**TOWN OF NEWBURGH
PLANNING BOARD
TECHNICAL REVIEW COMMENTS**

PROJECT: THE POLO CLUB SENIOR HOUSING
PROJECT NO.: 2018-12
PROJECT LOCATION: SECTION 39, BLOCK1, LOT 1 & 2.12
REVIEW DATE: 31 JANUARY 2019
MEETING DATE: 7 FEBRUARY 2019
PROJECT REPRESENTATIVE: ENGINEERING & SURVEYING PROPERTIES

**RE: POLO CLUB –AMENDED SITE PLAN
TOWN OF NEWBURGH
COMMENT RESPONSE**

OVERALL SITE PLAN

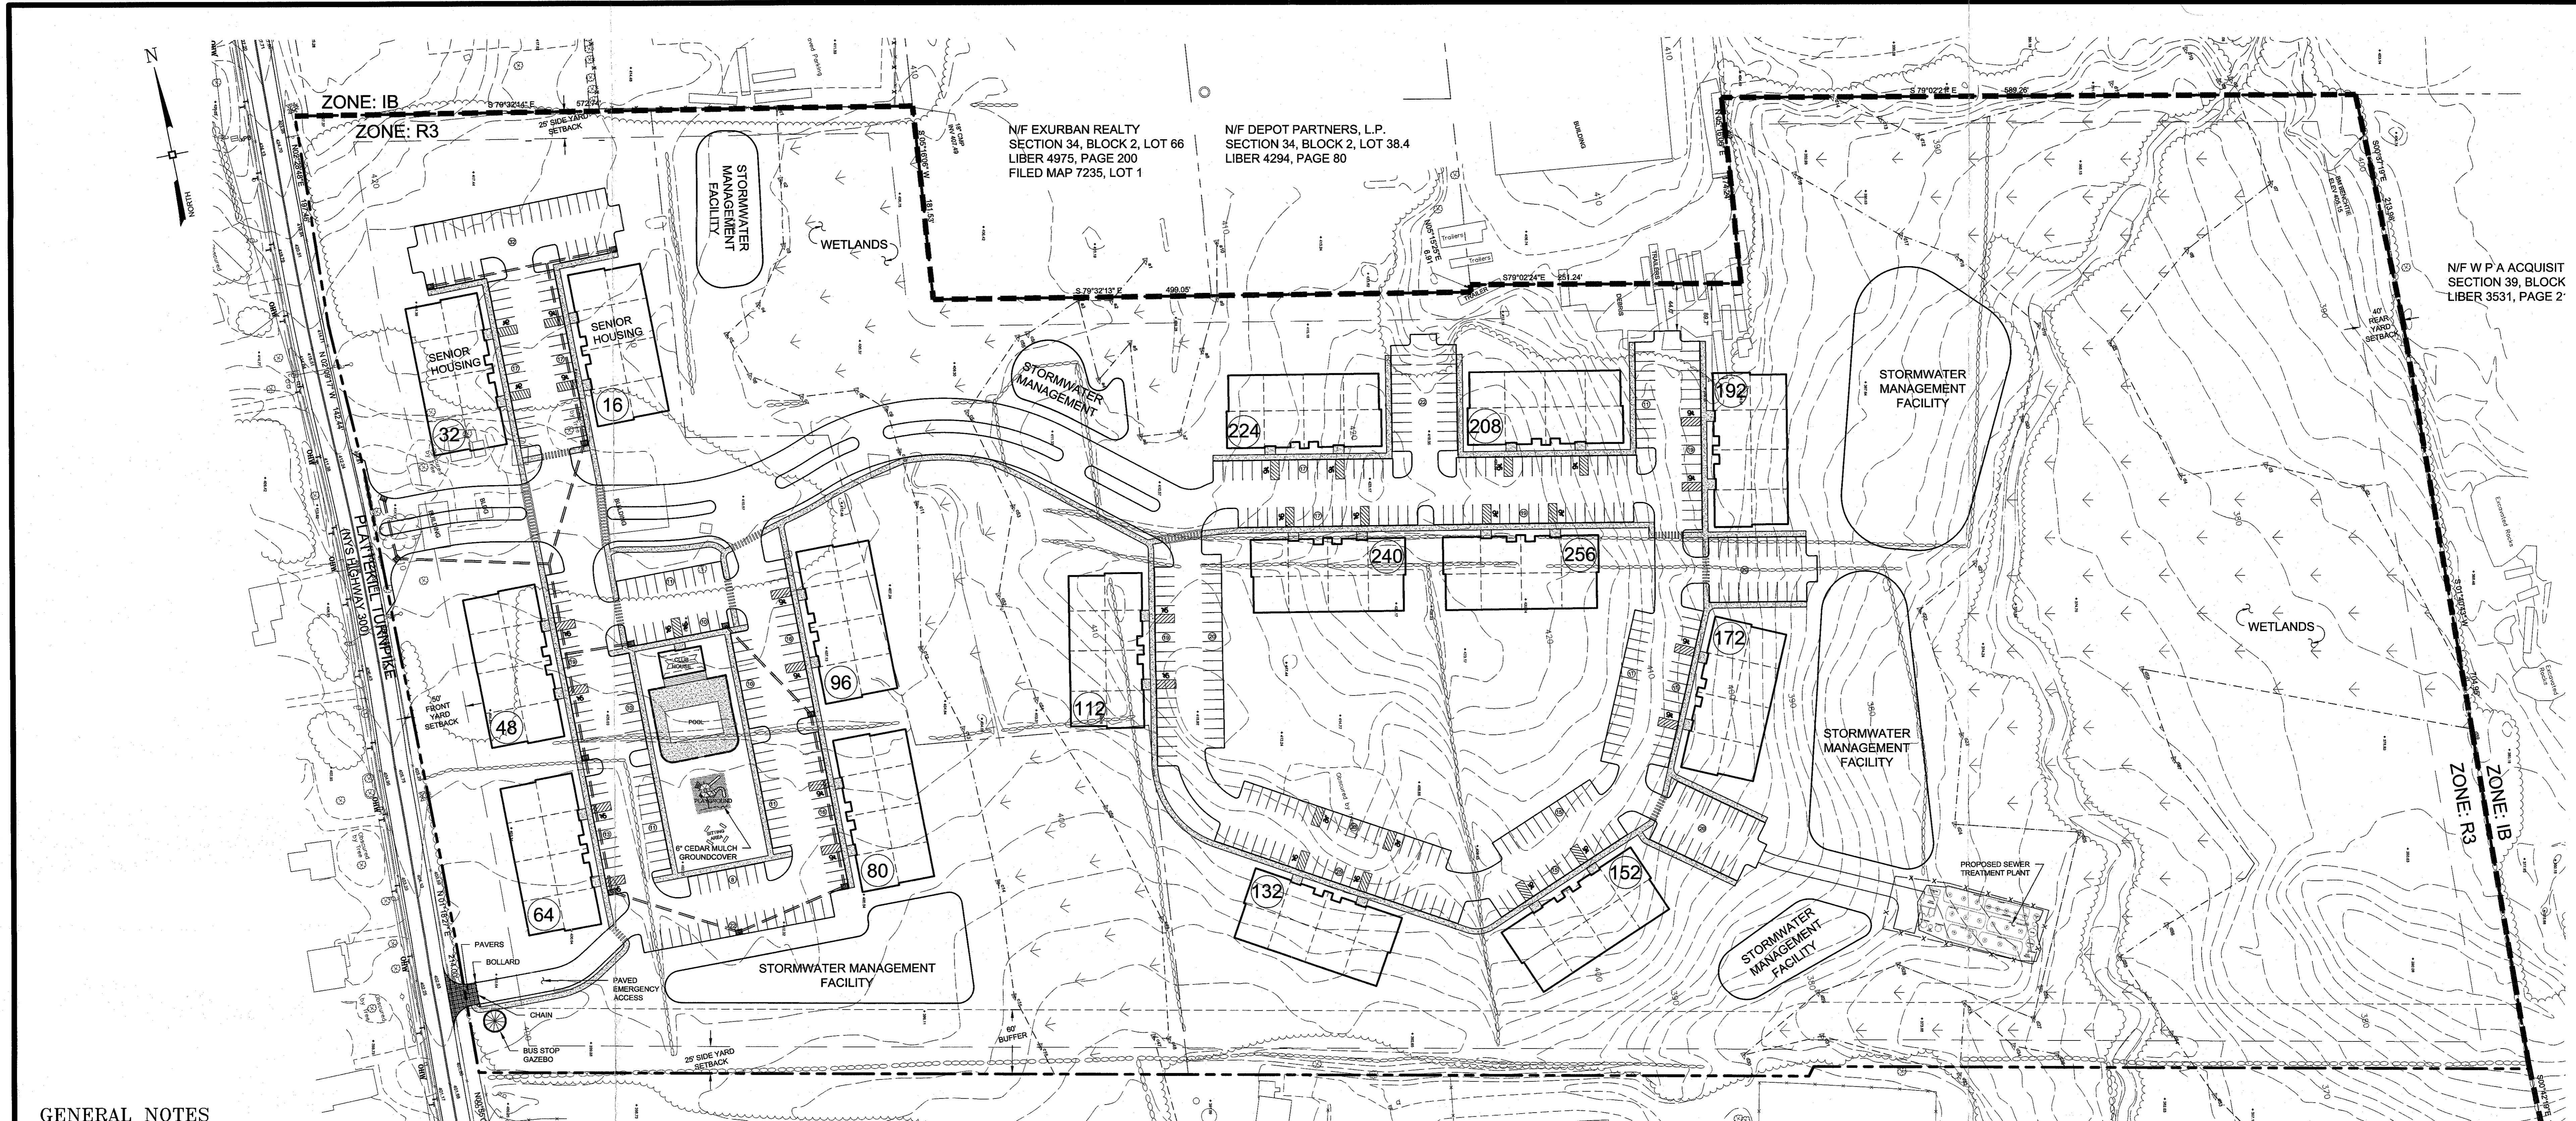
2. Dimension, the distance between the Buildings#240 & 256 identified as 48 and 64 and 96 and 80 for compliance with required separation distances based on building heights.

3. If buildings are proposed to have decks, the decks should be depicted on the plans.
4. The Planning Board should review the SEQRA Consistency document provided, which identifies the original SEQRA review versus the proposed plan. The Applicants are proposing to provide supplemental information to address potential impacts associated with the proposed project versus the previously reviewed project.

5. The plan should address landscaped islands within the parking areas. Parking lot landscaping in compliance with 185-13(9)(a) should be provided on the plans.

7. An emergency access drive has been provided on the southern portion of the Route 300 frontage. This access drive also provides a bus shelter for transportation of school age children.

1. A sidewalk has been added to the emergency access/school bus pick up location.
2. Based on preliminary grading plans, buildings 132, 152, 172 and 192 will be walkout buildings with 20 units each. This change has allowed us to remove the southern building on interior of the loop road at the rear of the site.

1. Access to the onsite buildings was discussed. It was recommended that additional breaks in the boulevard be added. These have now been included.
2. The emergency access was also discussed as the original plan did not call out this improvement and only showed it schematically. This has been further detailed on the plans.

3. Sewer plant access was discussed as the initial concept did not detail the access driveway. The driveway has now been shown,
4. Recommended locations of fire hydrants was discussed. These will be detailed on the design plans and confirmed with the Fire Department.
